PREVOST

**WARRANTY
BULLETIN**

WB13-63A

DATE :	OCTOBER 2013	SECTION :	06 - Electrical
EXPIRATION:	OCTOBER 2015		
SUBJECT :	70 AMP CIRCUIT BREAKER INSPECTION AND REPLACEMENT

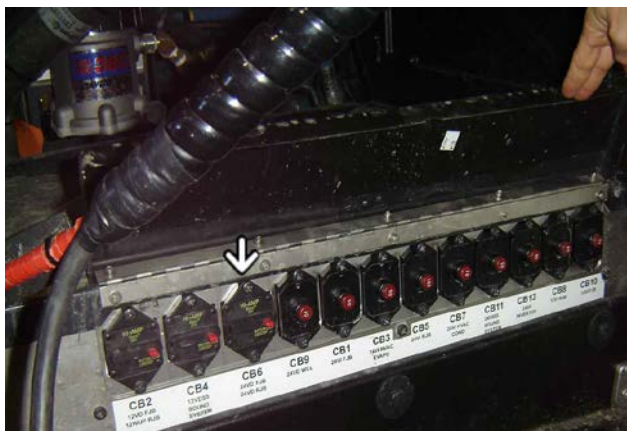
4. H3-45 VIP shells:

Locate CB4 and CB6

11. If fabrication code is within defective range **U19** to **V50 inclusively**, replace breaker with new part #563424.
